### Merged Document Report

Document Filename
Preliminary WTR & SSWR.pdf
SWQMP - PALMS AT MORRIS.pdf
FINAL PLAT_23-01798.pdf

**PLAT OF PALMS AT MORRIS SENIOR LIVING SUBDIVISION BLOCK 2, LOT 1**

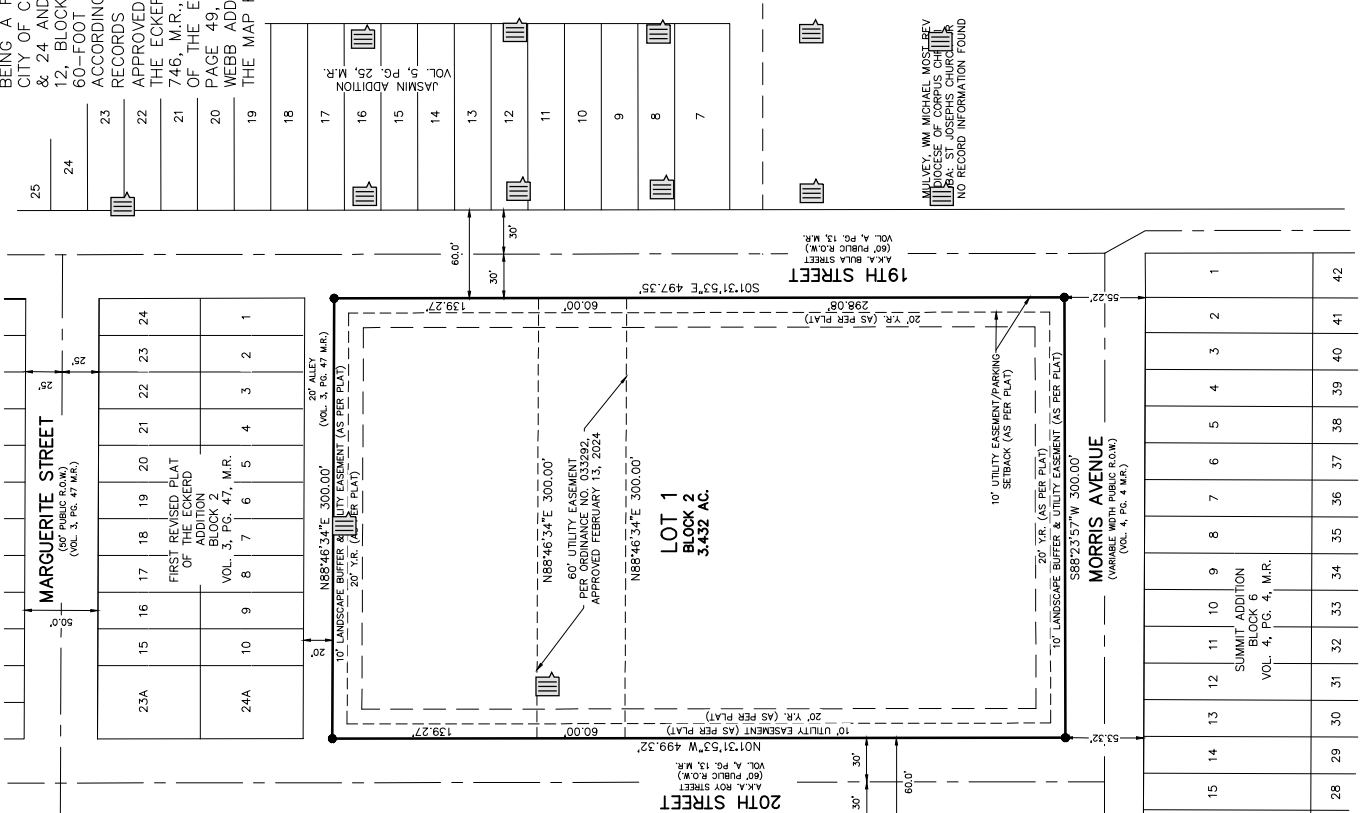
Comment ID	Page Reference	Annotation Type	Author : Department	Status	Review Comments	Applicant Response Comments
4	FINAL PLAT_23-01798-PG 1	Note	Andrea Fernandez : DS	Closed	Parks and Recreation is not responsible for areas containing landscaping or potential recreational activities under area "Outdoor Activity Area"	
5	FINAL PLAT_23-01798-PG 1	Note	Andrea Fernandez : DS	Closed	GIS Comments: 1 Plat The plat closes within acceptable engineering standards.	
6	FINAL PLAT_23-01798-PG 1	Note	Andrea Fernandez : DS	Closed	AEP Transmission: no comment on the subject plat	
7	FINAL PLAT_23-01798-PG 1	Note	Andrea Fernandez : DS	Closed	CCRTA comments: This plat located along 19th Street is served by bus route 21 Arboleda. Fortunately there is no bus stop or CCRTA equipment immediately adjacent to the proposed plat	
8	FINAL PLAT_23-01798-PG 1	Note	Andrea Fernandez : DS	Closed	AEP Distribution: No comment

Comment ID	Page Reference	Annotation Type	Author : Department	Status	Review Comments	Applicant Response Comments
9	FINAL PLAT_23-01798-PG 1	Note	Andrea Fernandez : DS	Closed	Planning comment: In plat description provide missing document number. UPDATED: Update correct ordinance number in plat description	
11	FINAL PLAT_23-01798-PG 1	Note	Andrea Fernandez : DS	Closed	Planning comment: Provide signature blocks per replat template (see comment ID #10)	
12	FINAL PLAT_23-01798-PG 1	Note	Andrea Fernandez : DS	Closed	Planning comment: Plat no longer a preliminary plat, change title accordingly.	
13	FINAL PLAT_23-01798-PG 1	Note	Andrea Fernandez : DS	Closed	Planning comment: Provide drainage basin in plat notes	
18	FINAL PLAT_23-01798-PG 1	Note	Andrea Fernandez : DS	Closed	Planning comment: Provide scale bar per replat template.	
19	FINAL PLAT_23-01798-PG 1	Note	Andrea Fernandez : DS	Closed	Planning comment: "20' Bldg Setback" to go around all of property and relabeled as Y.R. Yard Requirement.

20	FINAL PLAT_23-01798-PG 1	Note	Andrea Fernandez : DS	Closed	Fire comments 1-10: 1 Plat Note: All code reference is based on currently adopted International Fire Code (IFC) 2021 and Corpus Christi Water Distribution Standards. 2 Plat Commercial Development shall have a fire flow of 1,500 GPM with 20 psi residual Fire hydrant every 300 feet and operational." 3 Plat 507.5.1 (amendment) Where Required: All premises, other than one-family detached dwellings, where buildings or portions of buildings are located more than 150 feet from a fire hydrant shall be provided with approved on-site hydrants and water mains capable of supplying the fire flow require by the fire official. The minimum arrangement being so as to have a hydrant available for distribution of hose to any portion of building on the premises at distances not exceeding 300 feet. Exception: For buildings equipped with an approved automatic sprinkler system, the distance requirement shall be 500 feet. 4 Infor. 507.5.4 Obstruction. Unobstructed access to fire hydrants shall be maintained at all times. The fire department shall not be deterred or hindered from gaining immediate access to fire protection equipment or fire hydrants. Note: Hose

Comment ID	Page Reference	Annotation Type	Author : Department	Status	Review Comments	Applicant Response Comments
21	FINAL PLAT_23-01798-PG 1	Note	Andrea Fernandez : DS	Closed	<p>lay from a hydrant will not cross an arterial street.</p> <p>5 Infor. 12.2.3 (amendment) Proximity to Hydrant: Fire department connections (FDC) for each sprinkler system or standpipe system shall be located not more than 100 feet from the nearest fire hydrant connected to an approved water</p> <p>6 Infor. 503.1.1 (amendment) Buildings and facilities: Approved fire apparatus access roads shall be provided for every facility, building, or portion of a building hereafter constructed or moved into or within the jurisdiction. The fire apparatus access road shall allow access to three (3) sides of buildings in excess of fifteen thousand (15,000) square feet and all sides for buildings in excess of thirty thousand (30,000) square feet.</p> <p>7 Infor. 3310.1 Required access: Approved vehicle access for firefighting shall be provided to all construction or demolition sites. Vehicle access shall be provided to within 100 feet of temporary or permanent fire department connections. Vehicle access shall be provided by either temporary or permanent roads, capable of supporting vehicle loading under all weather conditions. Vehicle access shall be maintained until permanent fire apparatus access roads are available.</p> <p>8 Infor. 102.1 Access and loading: Facilities, buildings, or portions of buildings hereafter constructed shall be accessible to fire department apparatus by way of an approved fire apparatus access road with an asphalt, concrete or other approved driving surface capable of supporting the imposed load of fire apparatus weighing at least 75,000 pounds.</p> <p>9 Infor. 503.1.1 (amendment) Buildings and facilities: During construction, when combustibles are brought on to the site in such quantities as deemed hazardous by the fire official, access roads and a suitable temporary supply of water acceptable to the fire department shall be provided and maintained.</p> <p>10 Infor. Note: An accessible road and a suitable water supply is required once construction materials are brought on site.</p>

<p>Fire comments 11-20:</p> <p>11 Infor. 503.2.1 Dimensions. Fire apparatus access roads shall have an unobstructed width of not less than 20 feet, exclusive of shoulders and an unobstructed vertical clearance of not less than 13 feet 6 inches.</p> <p>12 Infor. 103.1 Access road width with a</p>

Comment ID	Page Reference	Annotation Type	Author : Department	Status	Review Comments	Applicant Response Comments
					<p>hydrant. Where a fire hydrant is located on a fire apparatus access road, the minimum road width shall be 26 feet, exclusive of shoulders.</p> <p>13 Infor. The minimum required width of 20 feet that shall be maintained means a clear unobstructed path that allows the passage of fire apparatus.</p> <p>1. Where Fire Apparatus Access is constructed to the minimum of 20 feet, no parking is allowed within the fire apparatus lane.</p> <p>2. Where a fire hydrant is located on the street, the minimum unobstructed clearance shall be 26 feet. In this instance, no parking is allowed on one side of the street.</p> <p>3. The minimum UDC residential street width is 28 ft. curb to curb. Any parking along the street that reduces the width to less than 20 ft. is prohibited and the Fire Code Official and will require painting "NO PARKING-FIRE LANE" along one side of the street."</p> <p>14 Infor. Note: Calculated Turning Radii for Fire Apparatus:  Inside Turn: 20 ft. 3 in.  Curb to curb: 36 ft. 8 in.  Wall to wall: 44 ft. 8 in.</p> <p>Note: The turning radius for fire apparatus should not be less than 45 degrees and curb to curb 36 feet. As a result, developers should be particularly careful not to design streets with acute angles that would prevent fire apparatus from completing a turn without having to back up to negotiate the turn."</p> <p>15 Infor. 105.1 Where required. Where the vertical distance between the grade plane and the highest roof surface exceeds 30 feet, approved aerial fire apparatus access roads shall be provided. For purposes of this section, the highest roof surface shall be determined by measurement to the eave of a pitched roof, the intersection of the roof to the exterior wall, or the top of parapet walls, whichever is greater</p> <p>16 Infor. 105.2 Width. Aerial fire apparatus access roads shall have a minimum unobstructed width of 26 feet, exclusive of shoulders, in the immediate vicinity of the building or portion thereof.</p> <p>17 Infor. 105.3 Proximity to building. At least one of the required access routes meeting this</p>

Comment ID	Page Reference	Annotation Type	Author : Department	Status	Review Comments	Applicant Response Comments
					<p>condition shall be located within a minimum of 15 feet and a maximum of 30 feet from the building and shall be positioned parallel to one entire side of the building. The side of the building on which the aerial fire apparatus access road is positioned shall be approved by the fire code official.</p> <p>18 Infor. D105.4 Obstructions. Overhead utility and power lines shall not be located over the aerial fire apparatus access road or between the aerial fire apparatus road and the building. Other obstructions shall be permitted to be placed with the approval of the fire code official.</p> <p>19 Infor. D503.4 Obstruction of fire apparatus access roads. Fire apparatus access roads shall not be obstructed in any manner, including the parking of vehicles. The minimum widths and clearances established in sections D103 shall always be maintained.</p> <p>20 Infor. D503.3 Marking: Where required by the fire code official, approved signs, or other approved notices the include the words NO PARKING-FIRE LANE shall be provided for fire apparatus access roads to identify such roads to prohibit the obstruction thereof. The designation of a fire lane can be marked with conspicuous signs which have the words: "Fire Lane-No Parking" at 50-foot intervals. In lieu of signs, fire lanes may be marked along curbing with the wording, "Fire Lane-No Parking" at 15-foot intervals.</p>

22	FINAL PLAT_23-01798-PG 1	Note	Andrea Fernandez : DS	Closed	<p>Fire comments 21-26:</p> <p>21 Infor. D103.4 Requirements for Dead-end fire apparatus access roads. Turnaround provisions shall be provided with a 96-foot diameter cul-de-sac.</p> <p>22 Infor. D503.2.5 Dead ends. Dead-end fire apparatus access roads more than 150 feet in length shall be provided with an approved area for turning around fire apparatus.</p> <p>23 Infor. D103.5 Fire apparatus access road gates. If installed-Gates securing the fire apparatus access roads shall comply with all the following criteria: Single gate width shall not be less than 20 feet. 12 feet gate width is required for a divided roadway. Electric gates shall be equipped with a means of opening the gate by fire department personnel for emergency access. Emergency opening devices shall be approved by the fire code official. Note: The use of a Knox Gate Switch is currently required by the Fire Official. Methods of locking shall be submitted for approval by the fire code official. Note: The Knox Padlock is currently required by the Fire Official. Electric gate operators, where</p>	<p>provided, shall be listed in accordance with UL 325.</p>

Comment ID	Page Reference	Annotation Type	Author : Department	Status	Review Comments	Applicant Response Comments
23	FINAL PLAT_23-01798-PG 1	Note	Andrea Fernandez : DS	Closed	<p>The Knox Padlock is currently required by the Fire Official. Electric gate operators, where provided, shall be listed in accordance with UL 325. Gates intended for automatic operation shall be designed, constructed, and installed to comply with the requirements of ASTM F 2200.</p> <p>24 Infor. 106.1 Projects having more than 100 dwelling units. Multiple-family residential projects having more than 100 dwelling units shall be equipped throughout with two separate and approved fire apparatus access roads.</p> <p>25 Infor. Note: The above cited references are for the purpose of providing minimal access into commercial property that will have sufficient width and will support the weight of fire apparatus.</p> <p>26 Plat Commercial development of the property will require further Development Services review.</p>

24	FINAL PLAT_23-01798-PG 1	Note	Andrea Fernandez : DS	Closed	<p>Planning comment: Provide ordinance number for street closure. UPDATED: Provide correct ordinance number, should be Ordinance No. 033292.</p>	
25	FINAL PLAT_23-01798-PG 1	Note	Andrea Fernandez : DS	Closed	<p>Planning comment: Remove utilities and leader notes pertaining to utilities from plat.</p>	
28	FINAL PLAT_23-01798-PG 1	Note	Andrea Fernandez : DS	Closed	<p>Traffic comments: 1 Plat No Comments 2 Informational: Any Proposed driveway access to a public City Street shall conform to access management standards outlined in Article 7 of the UDC (UDC 7.1.7) except as where otherwise stated in the Island Overlay zoning district 3 Informational: Per the Urban Transportation Masterplan, 19th St is a C-1 with a PCI = 91, Morris Ave is a local with a PCI=28 and 20th St is a local with a PCI= 72 4 Informational: Per City of Corpus Christi Code of Ordinances Section 49-2 A ROW Construction Permit, issued by Traffic Engineering, will also be required to perform work within or occupy public right-of-way separate of plat approval and infrastructure improvements. 5 Informational: For further information or to acquire a ROW Construction Permit please email ROWManagement@ctexas.com 6 Informational: Working without an approved</p>

Comment ID	Page Reference	Annotation Type	Author : Department	Status	Review Comments	Applicant Response Comments
29	FINAL PLAT_23-01798-PG 2	Note	Andrea Fernandez : DS	Closed	ROW Construction Permit will be considered non-compliance and can be subject to fines and / or citations. 7 Informational: Any new streetlights must follow the latest streetlight policy which currently necessitates concrete light poles	
31	FINAL PLAT_23-01798-PG 2	Note	Andrea Fernandez : DS	Closed	Planning comment: In planning commission signature block update chairman to Michael Miller and Secretary to Al Raymond, A.I.A.	
32	FINAL PLAT_23-01798-PG 2	Note	Andrea Fernandez : DS	Closed	Planning comment: In development services engineer signature block please add, P.E. C.F.M., C.P.M. after Bria Whitmire	
2	SSWR & WATR EXH	Note	Mikail Williams : WTR	Closed	Planning comment: Please remove "preliminary" notes in red text on both plat pages.
